Miami Lakes Library Branch

EXTERIOR IMPROVEMENTS AND COMPREHENSIVE INTERIOR RENOVATIONS

ADDENDUM NO. 8

13-JUL-2025

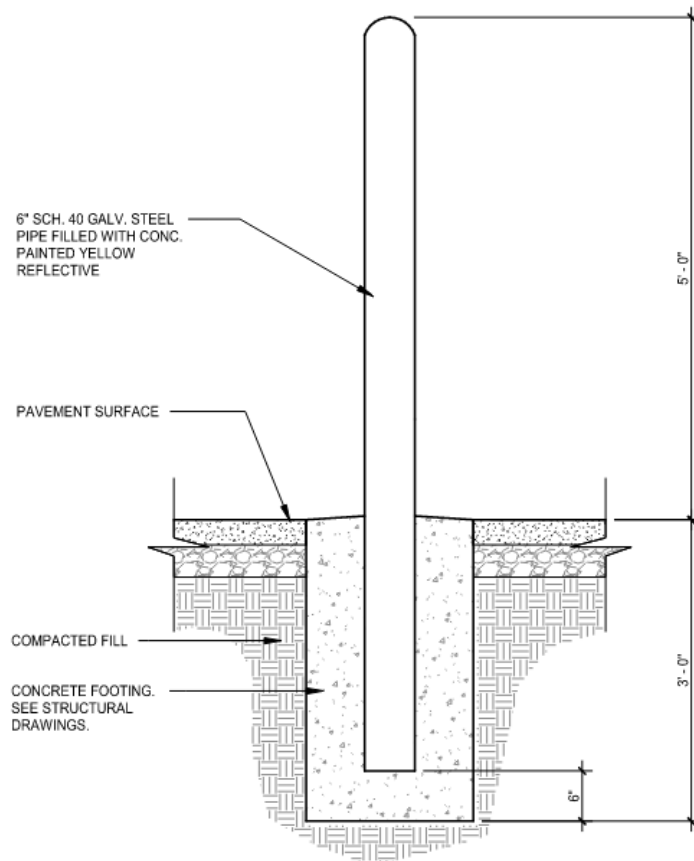
Q181. Provide the following specs:

1. specs for toilet partitions,
2. specs for ceiling grid,
3. specs for painting.

A181. *See responses below:*

1. *Bobrick Traditional Partitions, DuraLine Series CGL, Standard Privacy, or approved equal, finish TBD. Include barrel hinges, latch and keeper, bracket, coat hook, inswing door hardware and/or outswing door pull, and occupancy indicator.*
2. *See ACT-1 on finish schedule.*
3. *Paint shall be applied in the coats noted on the plans and per manufacturer specifications.*

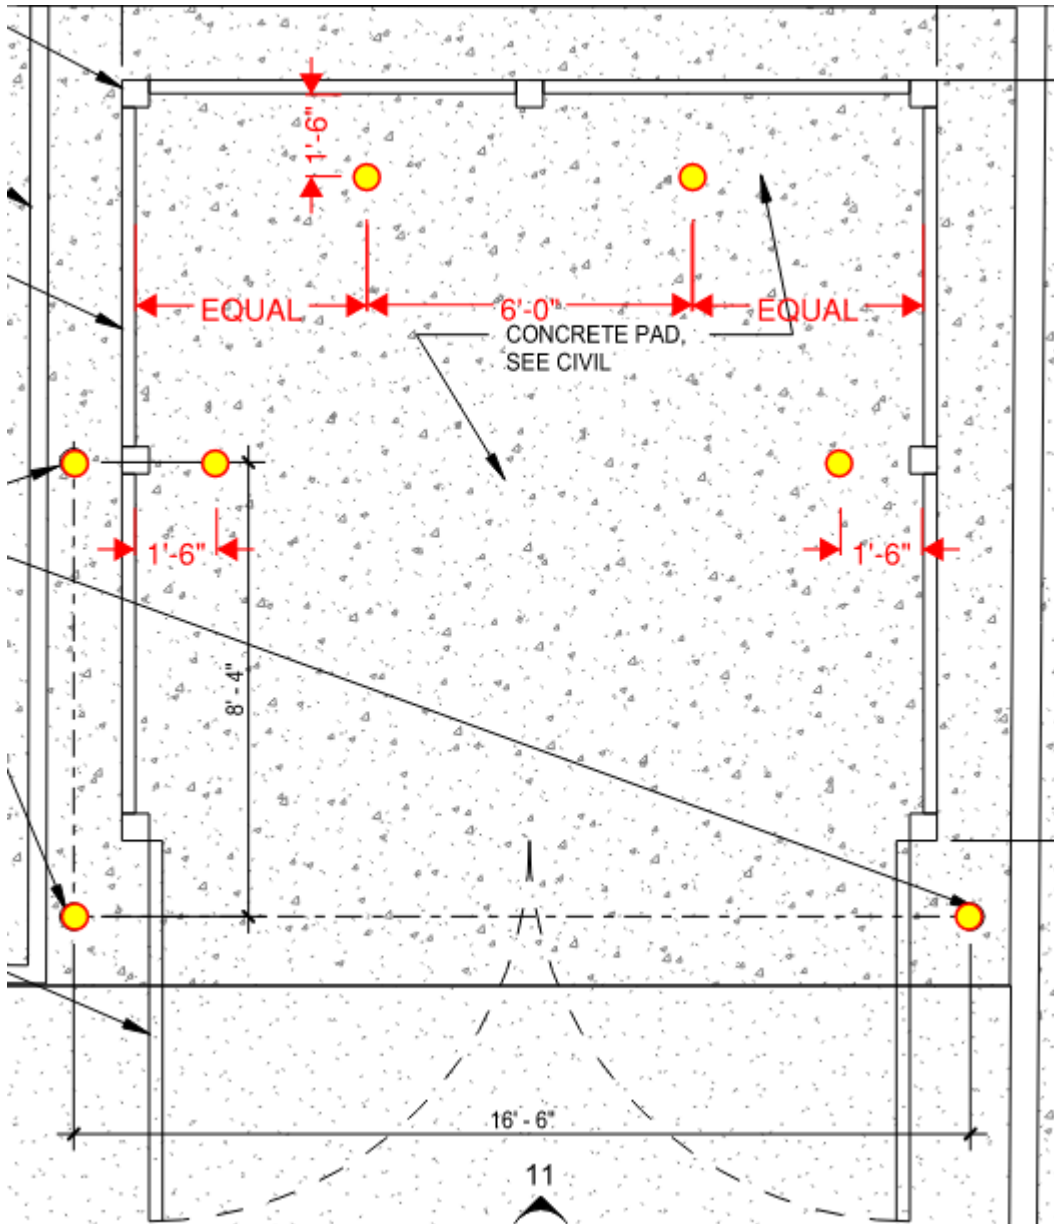
Q183. Please provide bollard detail and specifications for trash enclosure and book return box area.

A183. *See attached detail for the bollard. In addition, provide four additional bollards within the dumpster enclosure per sketch.*
